DEPARTMENT OF WATER RESOURCES

May 16, 2003

RE: SNAKE RIVER BASIN ADJUDICATION CLAIMS 45-212, 45-300, AND 45-2036
PRELIMINARY RECOMMENDATIONS

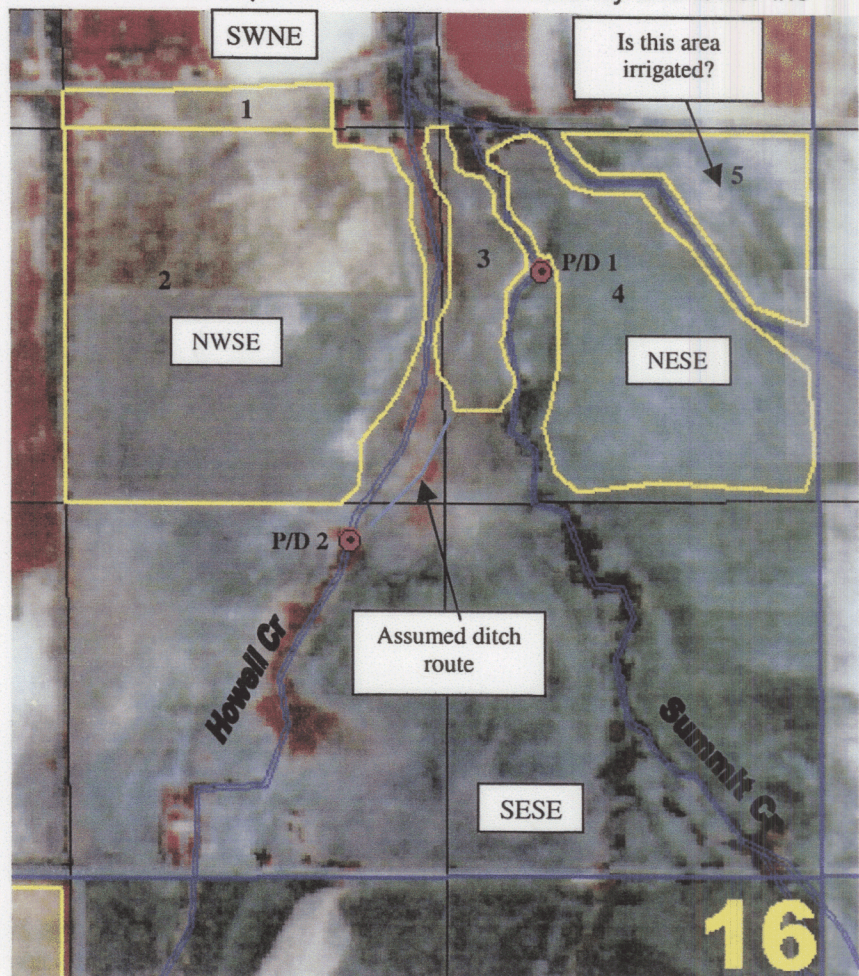
The combined place of use for the shapes outlined in yellow and numbered 1, 2, and 3 is approximately 43 acres. The combined acres for shapes 4 and 5 are 25 acres. I have not specifically visited the property so I do not have personal knowledge of the irrigated ground and have not make a determination at this time. The rights in the Albion valley were decreed at one inch per acre and this may have a bearing on the recommendations for your claims.

1. Where are all of the points of diversion located and what is the delivery system(s)?
2. Is the ground irrigated from the Summit Creek water system(s) independent from the ground irrigated from Howell Creek?

3. There is an approximate 3-acre parcel located in the SWNE of Sec 9 (identified as parcel 1). How long has that parcel been part of this farm? The original decreed place of use for 45-212 and 45-300 did not include the SWNE quarter.

45-212 The claimed source is Howell Cr but the marked point of diversion on the map included with the claim is on Summit Cr (labeled P/D 1).

45-300 This claim is also from Howell Cr but at the other marked location (P/D 2). It appears that this point of diversion supplies water to the middle shape.

45-2036 This claim indicates that it is for a pump located in the SESE of Sec 9. No map was included with the claim to identify the actual pump location. Where is the pump located, what is the horsepower, and how much water does it pump? The claim indicates that the place of use is 35 acres in the NESE and 10 acres in the NWSE. It is not obvious how this would be accomplished. Please provide additional information to explain this.
